# INDEPENDENT EXPERT ADVISORY PANEL FOR MINING

**METROPOLITAN COAL MINE**

**Stage 2: LONGWALLS 312-316**

**Report No: IEAPM 202503-02**

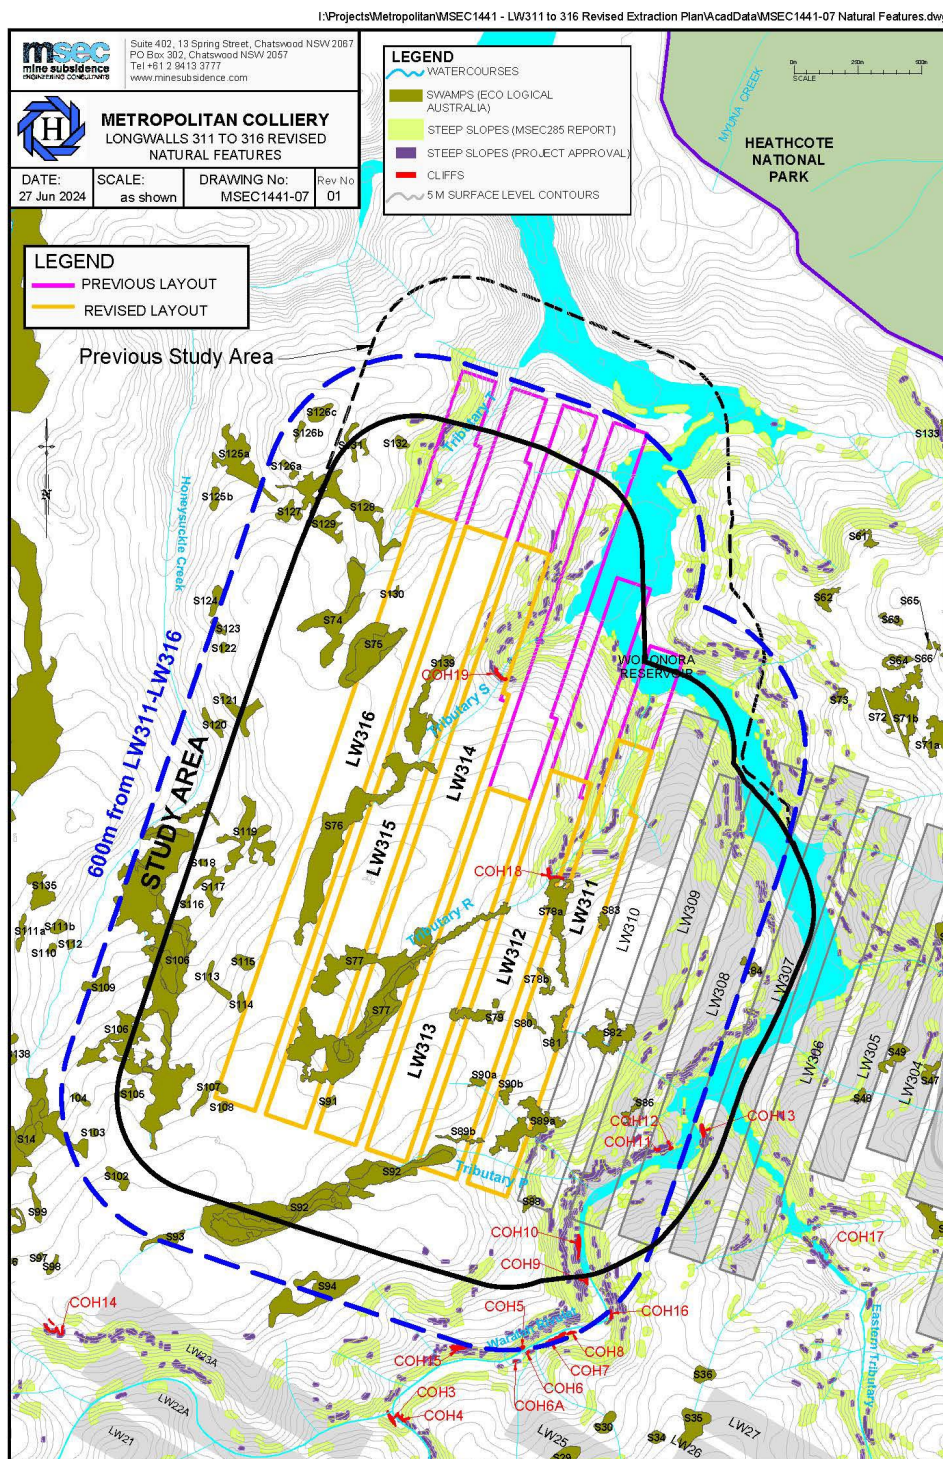
Longwall panel development has already advanced to a stage where the only mine design control now available for further reducing environmental consequences of extracting LWs 312-316 is to stand off from features. There is a view that if this control is applied to Swamps 76 and 77 it could result in an unviable mining operation. The control is feasible to implement in the case of Swamp 92, because only small portions of this swamp overly longwall panels and these portions are confined to the flanks of the longwall footprints (see Figure 3).

Figure 4: Predicted Versus Observed Valley Closure at Metropolitan Mine and other Southern Coalfield Mines (copied from supplementary information provided by Peabody to DPE 17/08/22).(IEAPM, 2022).

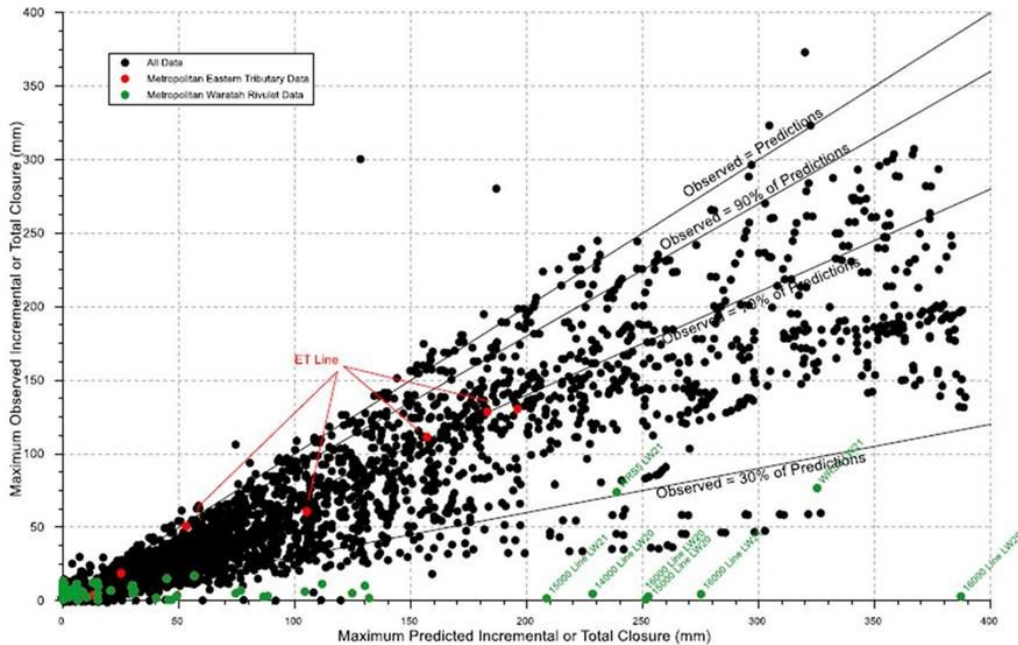
It remains the case that, as shown in Figure 4 (below), predicted valley closure does not correlate well with measured valley closure. This continues to be addressed by designing to an upper bound of predicted valley closure, meaning that measured valley closure is generally less than predicted. However, this poor correlation has implications for predicting impacts due to valley closure, since a range of outcomes can be associated with a given predicted valley closure. This has resulted in the illogical procedure of predicting valley closure impacts based on predicted valley closure rather than on a database of measured valley closure, because predicted valley closure values correlate better with resultant impacts than do measured values. The approach, illustrated in Figure 5, is based on the frequency of cracking of rock bars sufficient to result in a reduction in water being held back by the rock bar. It does not extend to considering other impacts of valley closure. The approach finds application across a number of mining operations in NSW, notwithstanding that it has been the subject of a number of reviews critical of the approach.

Figure 6: Profiles of cumulative valley closure for 3 different mine layouts evaluated for LW313 – 316 (Note: LW303 should read LW313). Source: (Peabody, 2024).

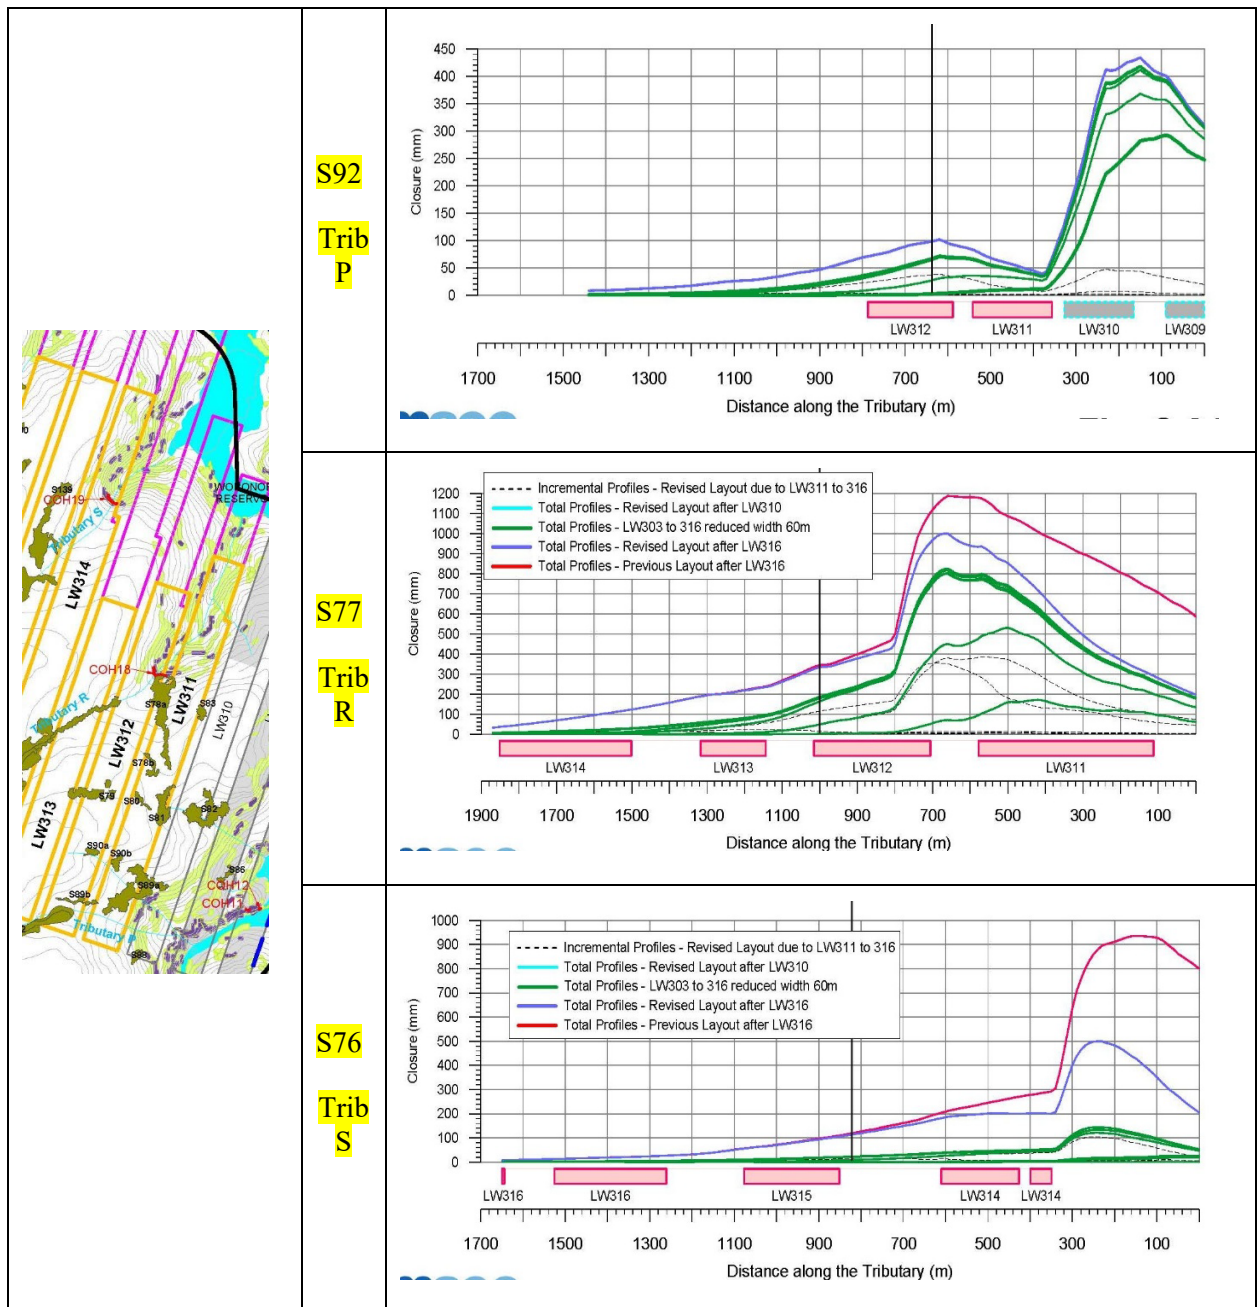
Against this background, Figure 6 provides an important basis for resolving some of the complexities associated with the EP for LWs 312-316 and the Panel’s advice. It shows the profiles of predicted valley closure for each of Swamps 76, 77 and 92 and their associated tributaries (S, R and P, respectively) for each of the following mine layouts:

Nevertheless, the Panel does not consider that the EP comprehensively addresses the PAC’s concerns regarding managing impacts on the valley infill sections of Swamps 76 and 77 and the environmental consequences of any impacts for the headwater sections of these swamps. Since the PAC’s concerns were not clearly captured in Schedule 3 Condition 4, this may have to stand. On this occasion, this may not have serious implications since, as reference to Figure 6 shows:

- Valley closure along tributary P within and immediately downstream of Swamp 92 is predicted to be less than 100 mm which, by reference to Figure 5, implies a very low likelihood of any

- Similarly, predicted valley closure along tributary S within and immediately downstream of Swamp 76 is predicted to be less than 120 mm which, by reference to Figure 5, again implies a very low likelihood of any significant valley closure impacts on Swamp 76.
- Predicted valley closure along tributary R within and immediately downstream of Swamp 77 is up to about 330 mm and, therefore there is a realistic likelihood of cracking and uplift of this tributary. Subsequent to its advice of 5/9/24, MC was able to provide an access route for the Panel to inspect the downstream end of Swamp 77. This inspection has not changed the Panel's views on the likelihood of valley closure induced impacts at this location. However, the inspection satisfied the Panel that it should be technically feasible to remediate impacts to the degree required to protect the integrity of this area of Swamp 77.
